**Planning Department
Transportation Development Services**

**Re: Office/Warehouse, 8620 President Place
Traffic Circulation Layout**
Architect's Stamp dated 11-19-14 (C17-D122)

SITE PLAN / TCL, SITE DETAILS

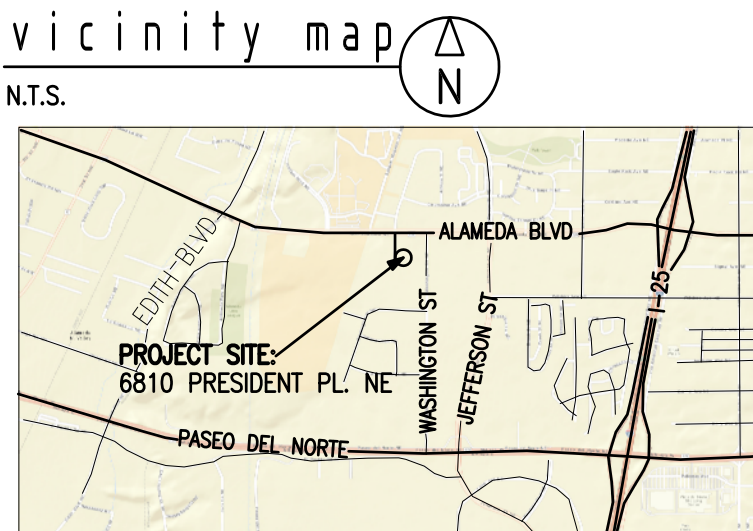
1. Please provide a zone atlas number for the vicinity map.
2. Per the DPM, a 6 ft. wide ADA accessible pedestrian pathway is required from both President Place and the parking lot to the building entrances. Detail 15 shows a ramp that is only 3'-6" wide, and it needs to be widened to 6 feet.
3. Detail 15 conflicts with the construction of a drivepad. If you are building a drivepad, no wheelchair ramp is needed.
